UNITED STATES  
DEPARTMENT OF THE INTERIOR  
BUREAU OF LAND MANAGEMENT

SUNDRY NOTICES AND REPORTS ON WELLS **AUG 01 2008**

Energen Resources would like to change the name of the San Juan 30-4 Unit #105S to the San Juan 30-4 Unit #105 and drill the east half of the spacing unit from the staked surface hole location of 1180 fsl, 1965 fel. The new BHL will be 760 fsl, 760 fel. 7" Intermediate casing will be set at 4600' MD with no change in cement volumes. The new TD of the well will be 7739' MD.

WELL LOCATION AND ACREAGE DEDICATION PLAT

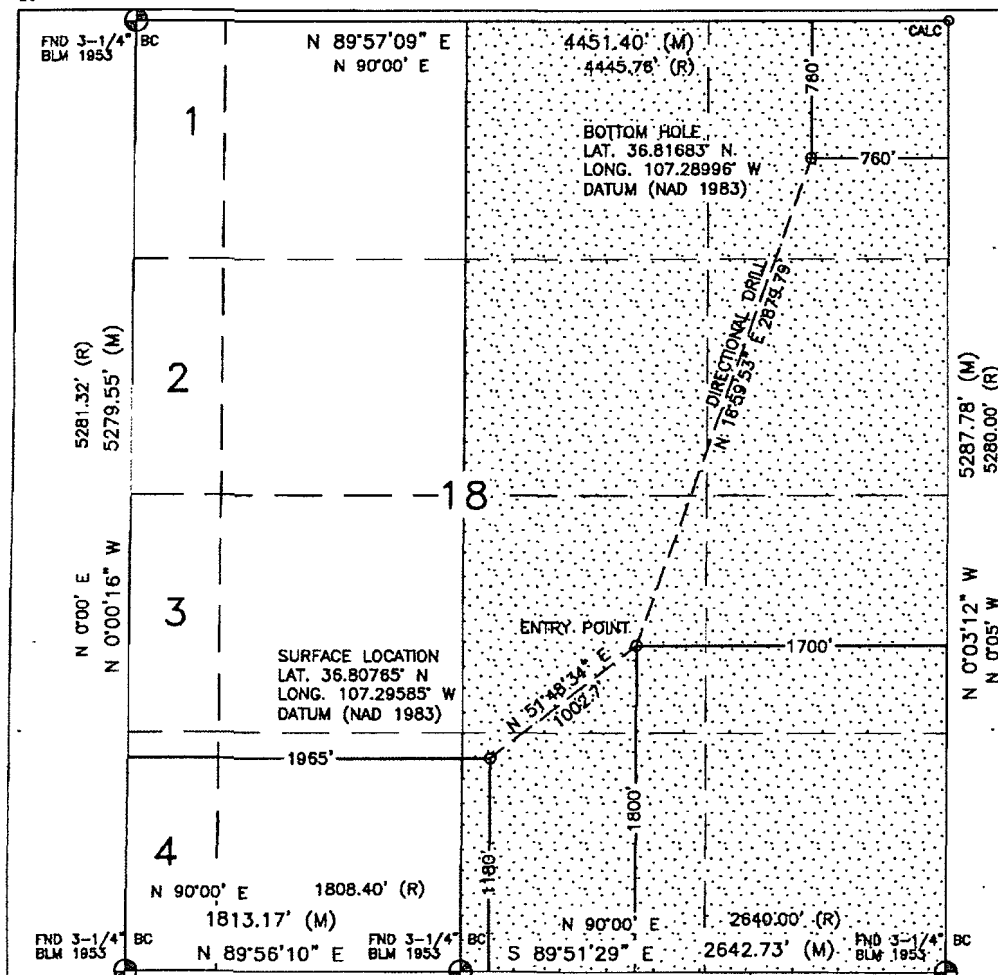
A revised C-102, Operations Plan, and Directional Drilling Plan are attached.

UL or lot no.	Section	Township	Range	Lot Idn	Feet from the	North/South line	Feet from the	East/West line	County
A	18	30N	4W		760'	NORTH	760'	EAST	RIO ARRIBA
